Executive Director's Recommendation

Commission Meeting: March 5, 2026

PROJECT East Wing Modernization Project White House Grounds 1600 Pennsylvania Ave, NW Washington, DC	NCPC FILE NUMBER 8733
SUBMITTED BY Executive Residence at the White House	NCPC MAP FILE NUMBER 1.31(64.00)46157
REVIEW AUTHORITY Federal Projects in the District per 40 U.S.C. § 8722(b)(1) and (d)	APPLICANT'S REQUEST Approval of preliminary and final site and building plans
	PROPOSED ACTION Approve preliminary and final site and building plans with comments
	ACTION ITEM TYPE Staff Presentation

North and South Elevations – With Landscape

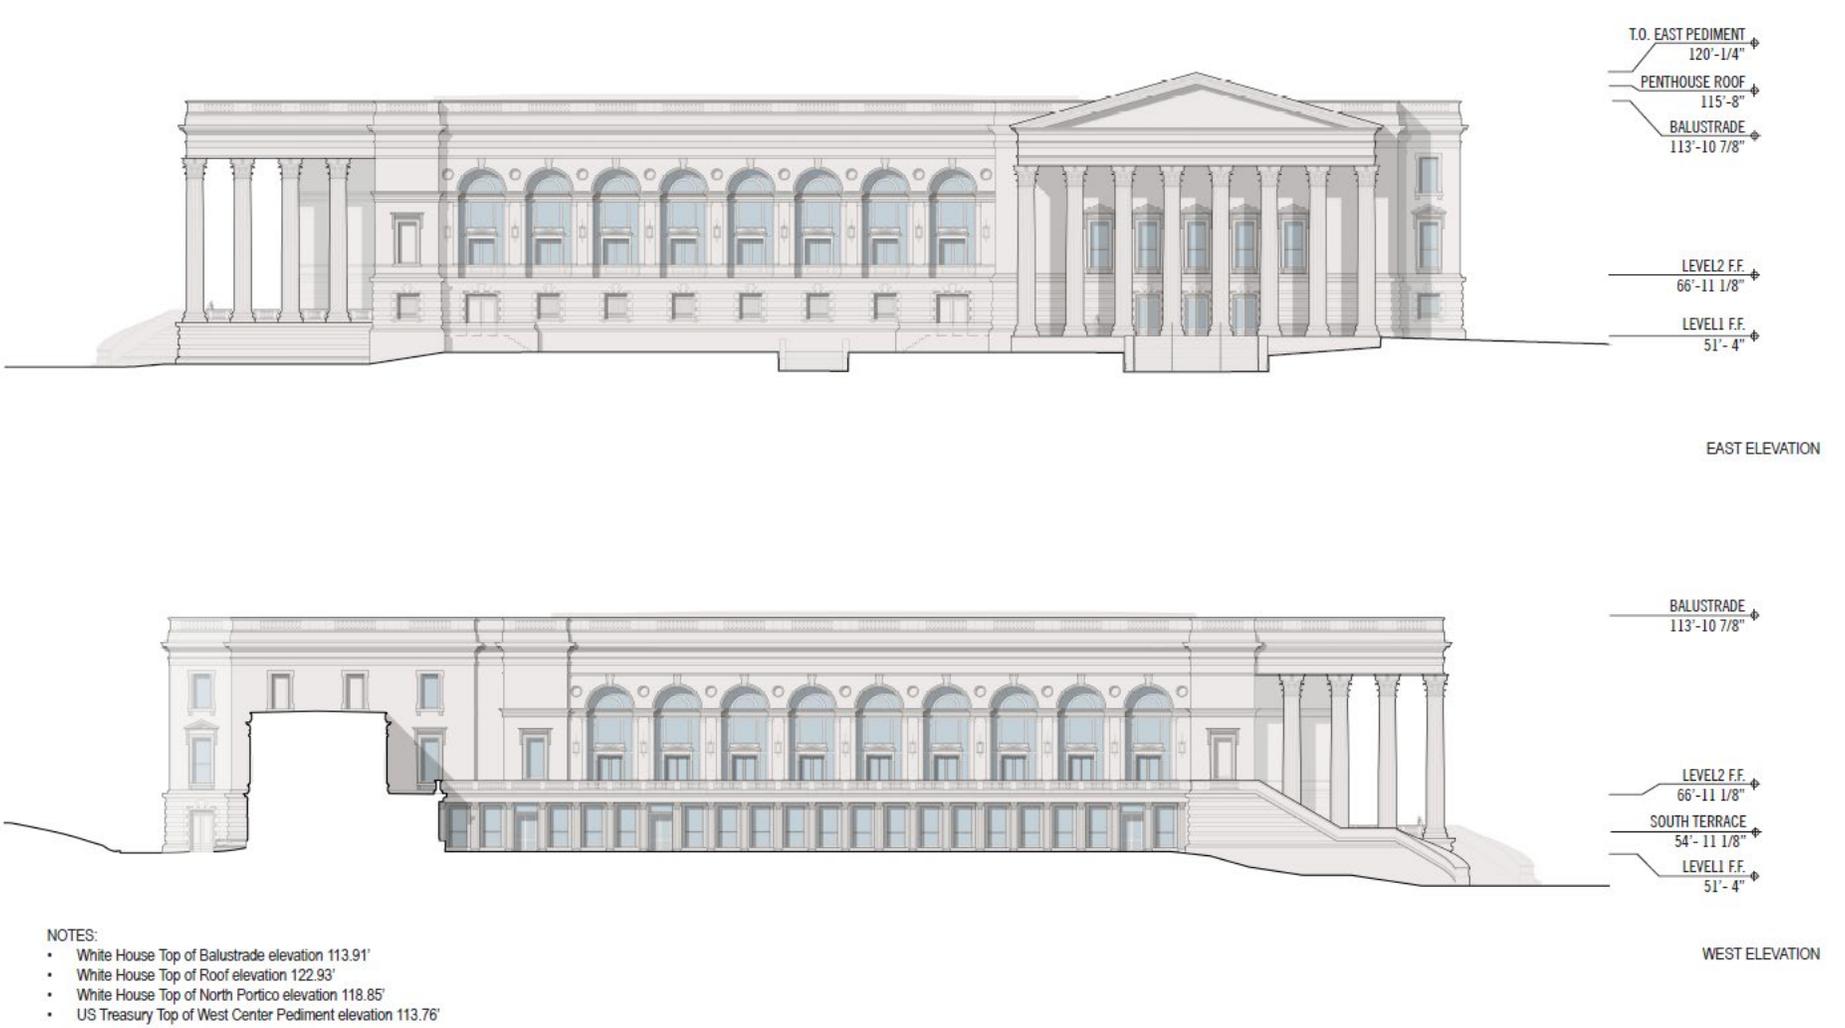
Finds that, per the viewshed study provided in the submission, the existing landscape will substantially screen views of the project from surrounding public spaces.

Finds that, per the viewshed study provided in the submission, the main views of the Executive Mansion from E Street to the south and Pennsylvania Avenue to the north will largely be maintained.

SOUTH ELEVATION

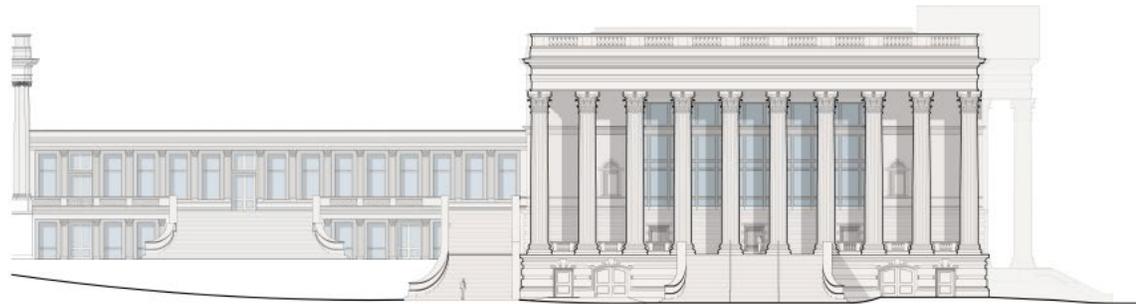
The project design has continued to evolve since the information presentation on January 8, 2026. In particular, after further consultation, the triangular pediment on the south façade was removed so that the balustrade/roofline consistently wraps the building. Staff finds this change successful, as it reduces the actual height and unifies the design. Therefore, staff recommends the **Commission express support for the applicant's removal of the pediment on the south elevation which results in a lower building height and a more unified architectural language for the project, along with a consistent roofline.** The updated design reduces the overall heaviness of this building elevation.

Likewise, there may be an opportunity to continue to improve the overall south portico design. In particular, the density of columns appears to create a heavy and dark façade. As such staff recommends the **Commission advise that, if there is an opportunity, the applicant continue to refine the south portico design, including column placement and spacing, to ensure an open, inviting area that also allows for improved natural light for the ballroom space.**

Supports the applicant's removal of the pediment on the south elevation which results in a lower building height and a more unified architectural language for the project, along with a consistent roofline.

Advises that, if there is an opportunity, the applicant continue to refine the south portico design, including column placement and spacing, to ensure an open, inviting area that also allows for improved natural light for the ballroom space.
